## Index 521-510

### Concrete Barrier/Noise Wall (8'-0")

**FRONT FACE ELEVATION**

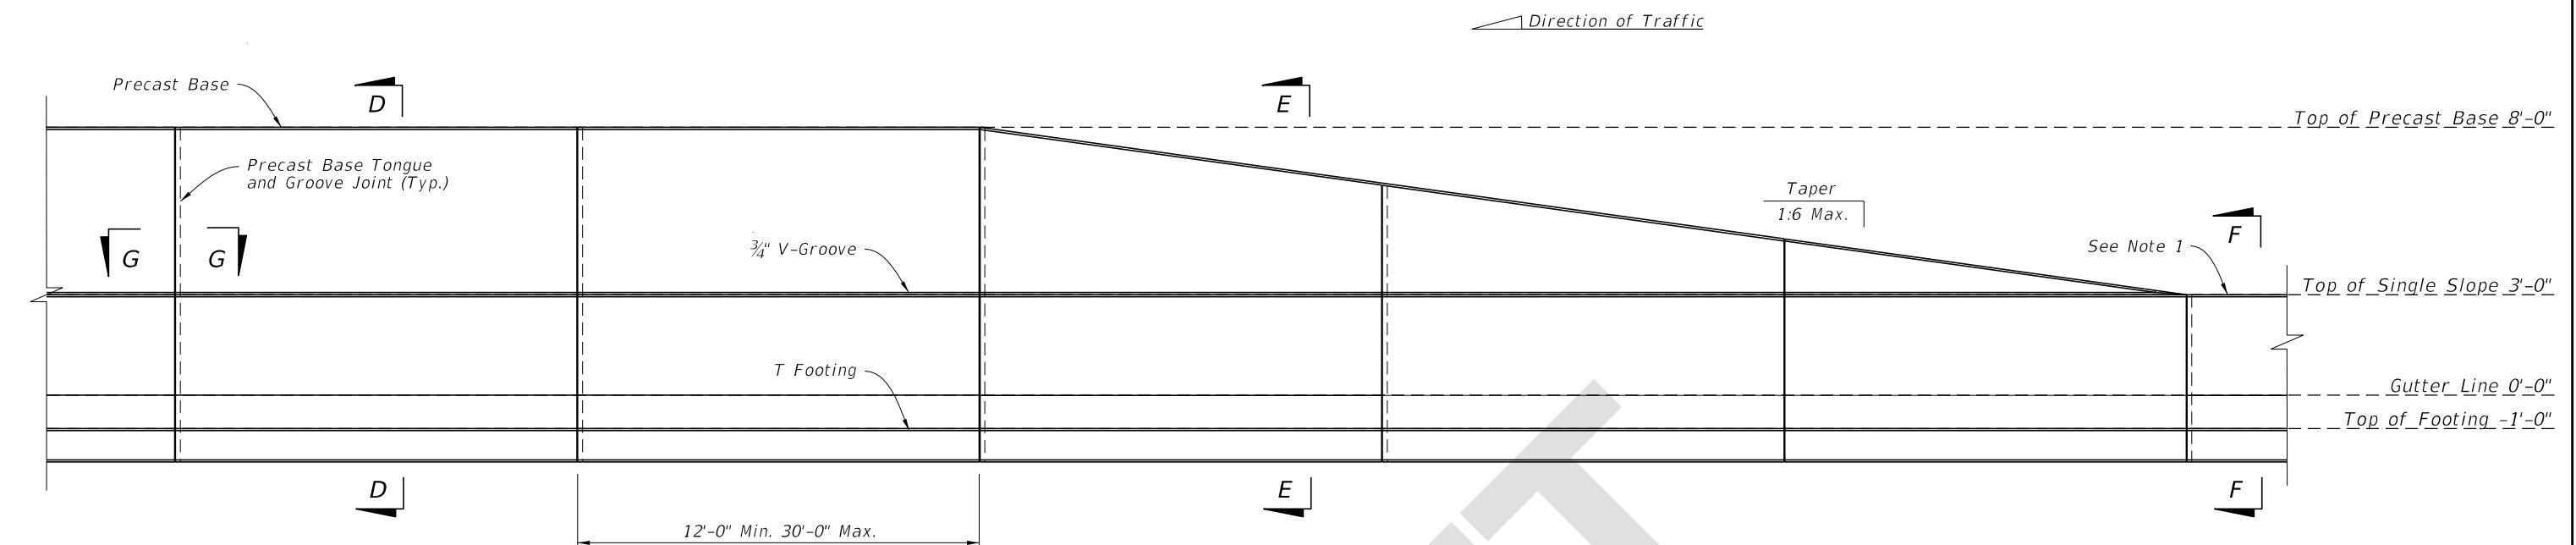
**COMMENT:** Tapered section for the precast options (Indexes 521-510 and 521-511) have labels stating "Field Cut Bars as Required for Taper". If the tapered sections are to be precast, then the bars cannot be "field cut". Either show that the tapered sections are cast-in-place or change the note to "See Roadway Plans for Taper Length" (or similar). Also, the detail of the reinforcement in the Front Face Elevation View should show top longitudinal bar to be parallel to the taper of the wall.

Index 521-511 (Sheet 5 of 6): Section D-D should show a grout tube and Bar 9C1. Also, tapered section below Top of Precast Base (8'-0"), should have additional information (sections, labels, etc.). That tapered section resembles Index 521-510.

**RESPONSE:** Agree with these comments. We will update both Indexes to accommodate.

**CHANGE MADE TO INDEX:** Yes.
